# 23/1237/RES Phase 3 And Seabrook Square, Exeter Cycling Campaign Response

The Exeter Cycling Campaign is grateful for the opportunity to respond to the planning application 23/1237/RES Phase 3 And Seabrook Square and offers the following comments.

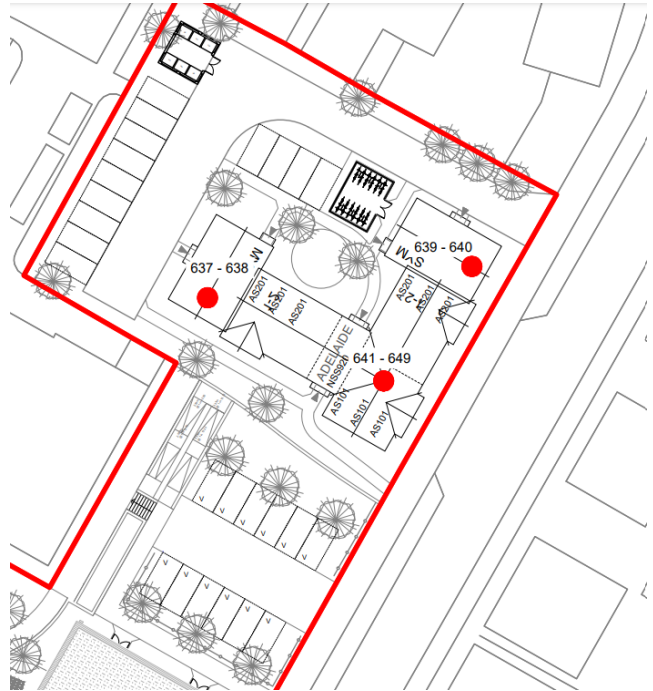
It is not clear to us whether the bike stores for the residential areas are secured or not. One drawing implies there are no doors to the cycle store. If these are intended for residential accommodation then they need to be secure.

We have concerns about the locations of the cycle parking for Seabrook Square. The NPPF paragraph 29 lays out that *“the transport system needs to be balanced in favour of sustainable transport modes, giving people a real choice about how they travel”*. We are unsure whether the cycle shed at the north end of the Square is for residents or visitors to the community building. If the former and not the latter then there is no safe, easily-accessible cycle parking for visitors to the community hall. Can this omission please be corrected. See [LTN 1/20](#) section 11 for standards for cycle parking.

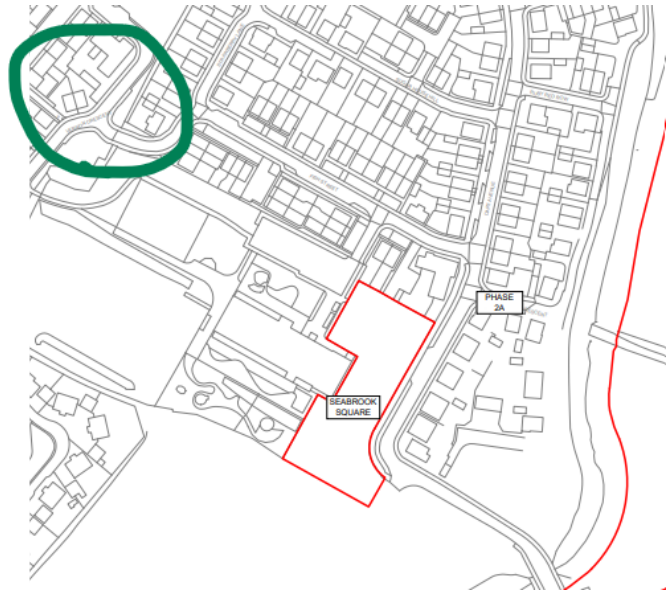
**Active travel link:** We were heartened to read on the DAS that “A pedestrian and cycle link is provided in the NE corner of the site onto the existing network at Newcourt Road” but are struggling to see this explicitly confirmed in the drawings. Can we clarify that this pedestrian/cycle link (circled in red) is this link?

**Link to Admiral Way:** There is currently no access/egress from Dart Ave onto Admiral Way (blue circle). We understand this to be because of a condition based upon a condition of occupancy of an earlier application requiring it to be opened prior to the occupation of not more than 650 dwellings. We would ask that this occupancy level is accessed and, if the condition met, action taken to open this for active travellers so that there is a reasonable route from the Phase 3 development NE along Admiral Way to the shop and Newcourt community hall.

**Fish Street ransom strip:** the access to Fish Street from Vernon Crescent has recently been blocked. (green circle). This created particular difficulties for children and parents travelling by foot, scooter or bike from Newcourt to the school and safely onto Topsham. This requires urgent attention to unblock again and we would ask that this is included in the design / consenting / contributions for this development.

The Topsham Millenium Wood will be an important natural space for residents on this Phase 3 development. It is not clear what the access to this wood will be. The drawings are not clear. Can it be confirmed that there will be three (shown in red circles) access points to the wood?
